City of Richmond

Report to Development Permit Panel

Re: **Application by Christopher Bozyk Architects on behalf of Open Road Toyota for a Development Permit at 13100 Smallwood Place**

**1. DP 18-818762 – TWO-STOREY ADDITION FOR INVENTORY PARKING TO
TOYOTA DEALERSHIP**

WHITE PERFORATED PANEL WITH 2'x2' DIA PERFORATION

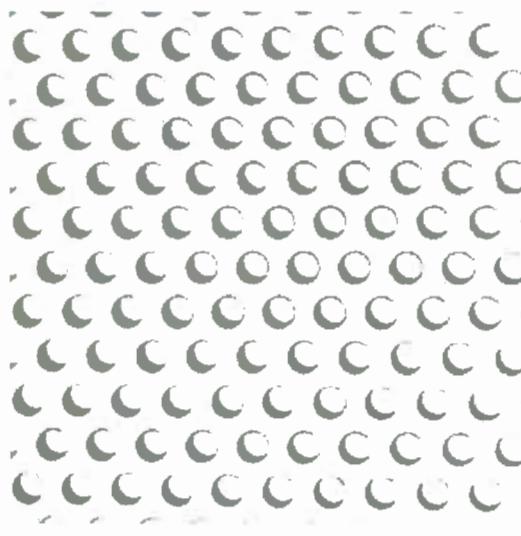
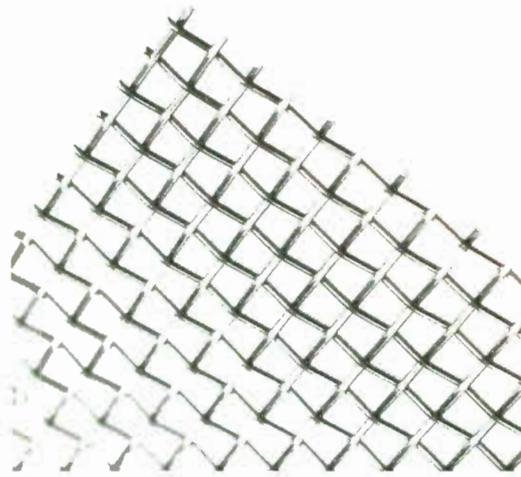
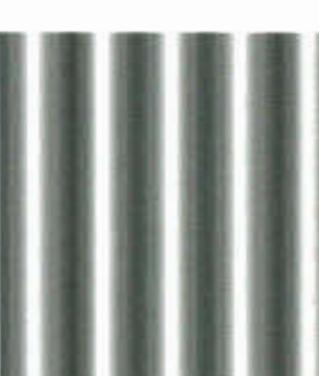
- support the white perforated metal panel option for the cladding of the parkade addition; the choice of perforated panel with skewed joints appears consistent with some of the geometry of the angled buttress frames on Jacombs Road elevation; ***Noted.***

- in order to ensure the success of cladding option 1 (i.e., perforated metal cladding), the applicant needs to (i) ensure that the perforation does not touch the perimeter of the panel, (ii) determine the extent of visibility of the view behind the panel so that the panel will not lose its visual strength (white is a preferred colour to achieve this objective), and (iii) consider a low sheen white colour with a little bit of texture so it will not create a reflective surface; ***We are in discussion with the fabricator about details which avoid having any cut perforations at the panel perimeter. It is intended to have a dark colour behind the panels to allow the panels keep their visual strength. Samples have been requested of a lower sheen surface finish.***

13100 SMALL WOOD PLACE, RICHMOND, BC
SHADOW ANALYSIS
SCALE: 1:2000
DATE: 2019-01-22
PROJECT NUMBER: 214077

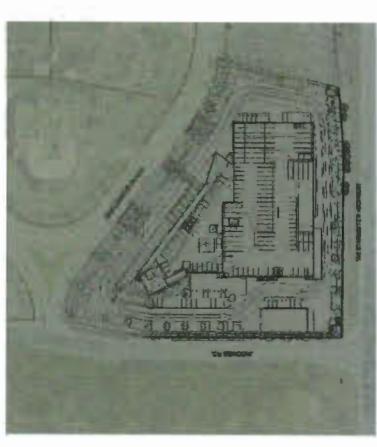
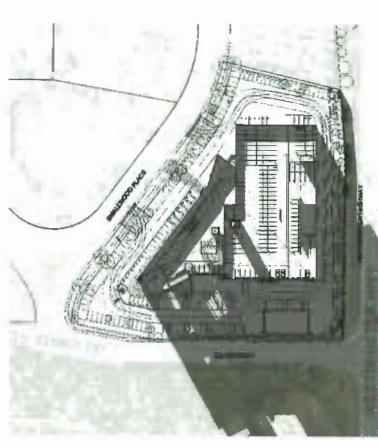
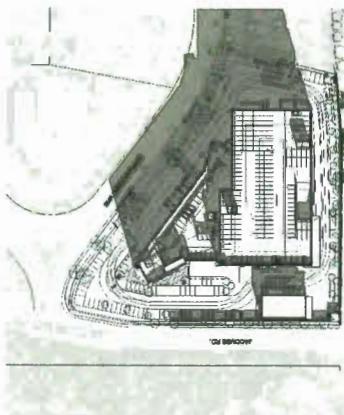
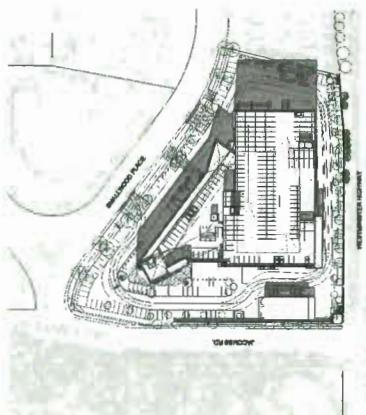
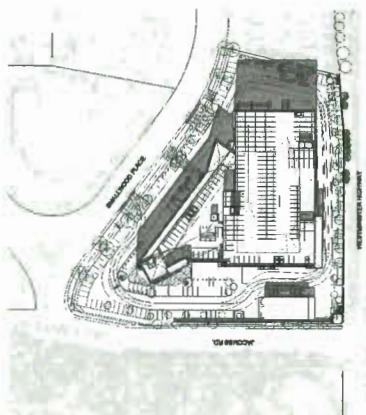
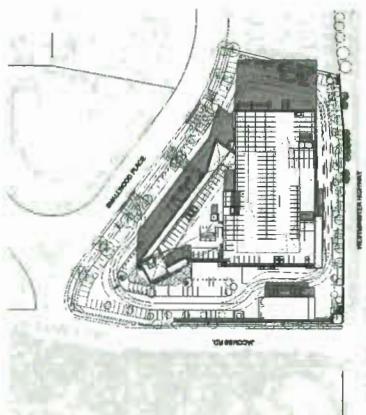
- In response to concerns raised at Planning Committee regarding potential sun shading of the Richmond Nature Park located approximately 42.5 m (139.4 ft) to the east, the applicant undertook a detailed shadow impact analysis (refer to the attached sun shadow analysis diagrams in the plan submission). The analysis indicates that shading of the periphery of the park will occur at several times through the year, limited to early morning hours. The diagrams indicate the duration of the shadowing to be typically short (on the order of an hour after sunrise at the extremes).

Plan #14

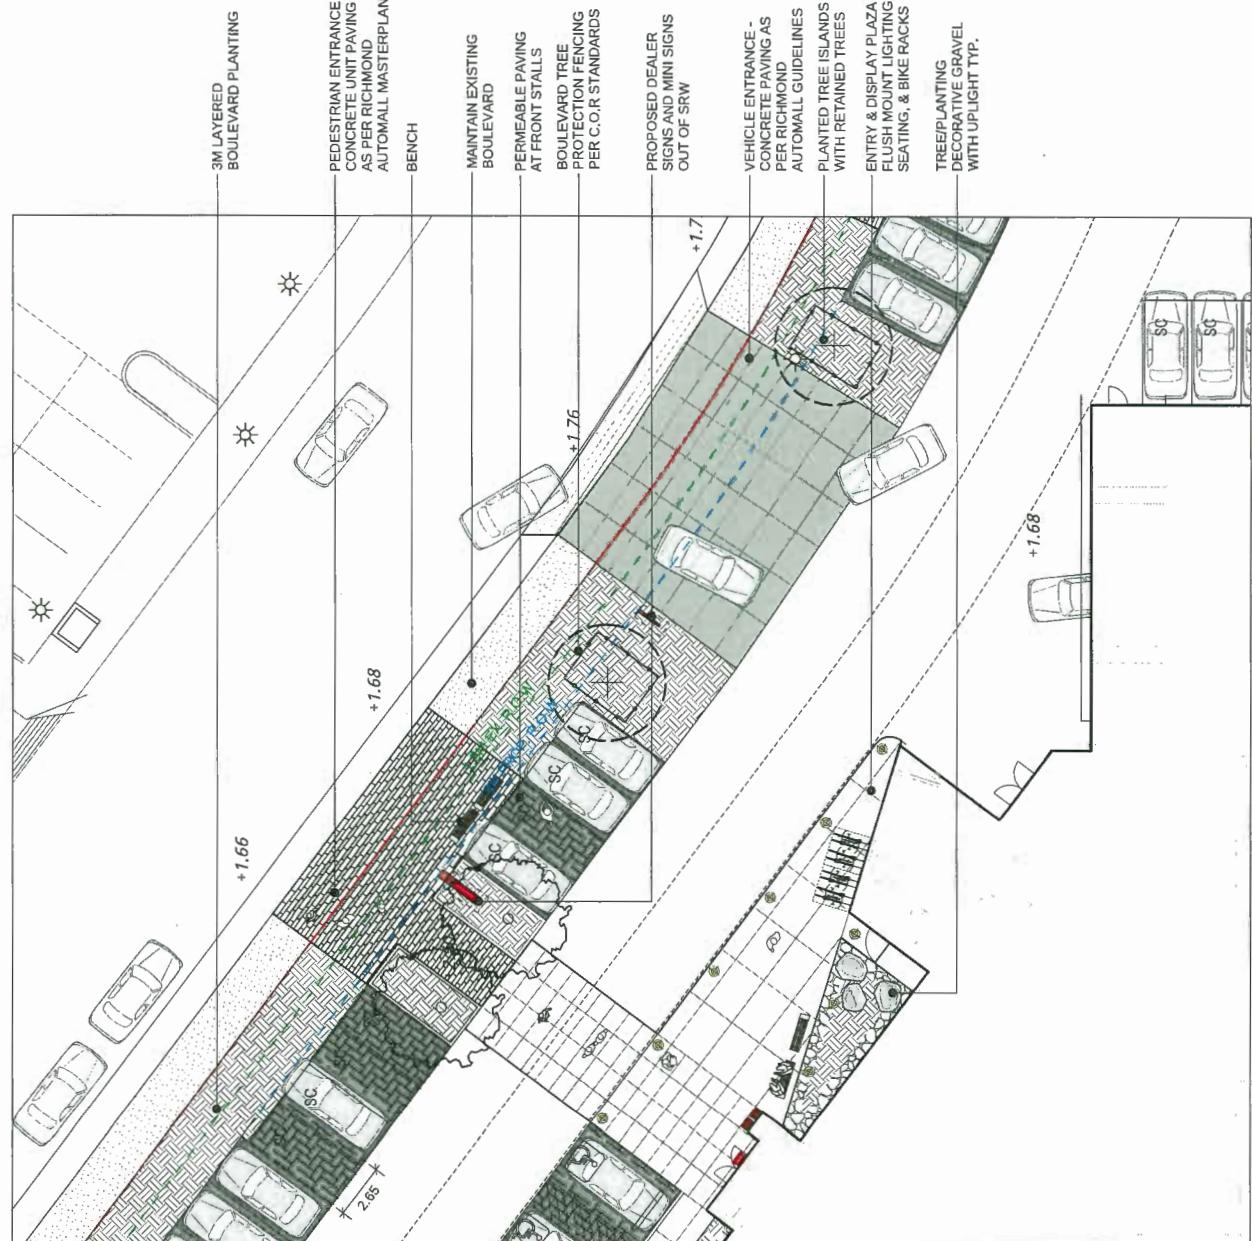
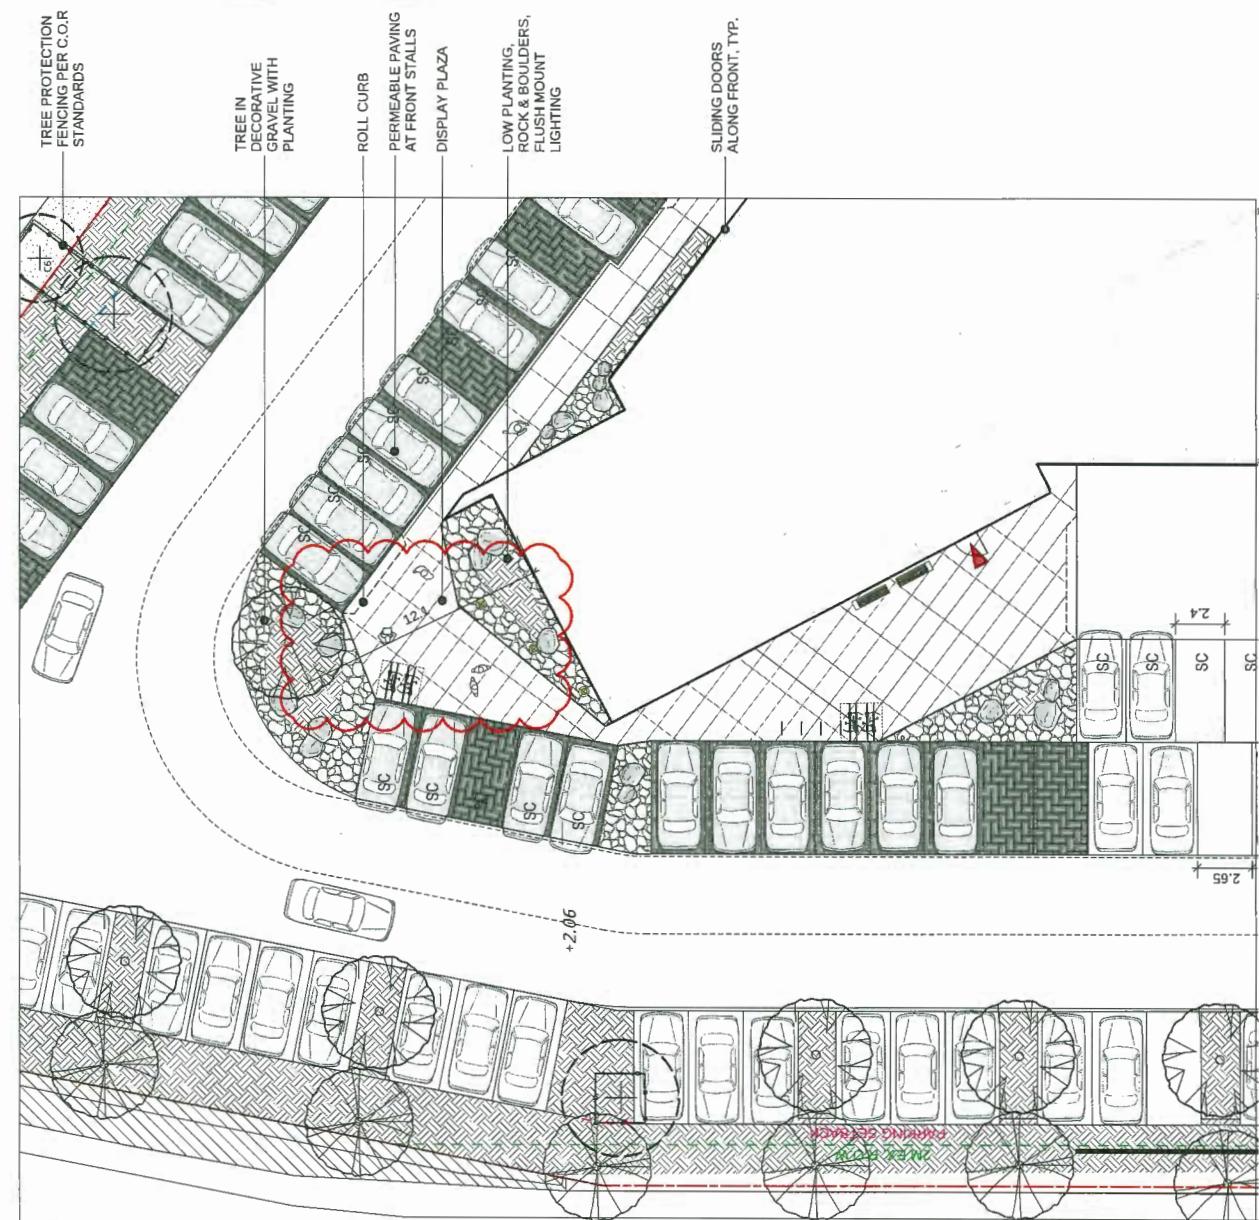
- Reviewing landscape modifications – particularly within 10 m of the building; (*The applicant has advised that the landscape plans have been revised to ensure that there are no plant over 30 cm in height within 10 m (32.8 ft.) of the building as recommended by the Ornithologist report. In addition, the number of trees has been reduced from 85 to 71 trees in the landscape plans as part of the bird mitigation strategy.*)

NOTE: ALL TREES/PLANTING WITHIN 10 METRES OF THE BUILDING TO BE LESS THAN 30CM IN HEIGHT.
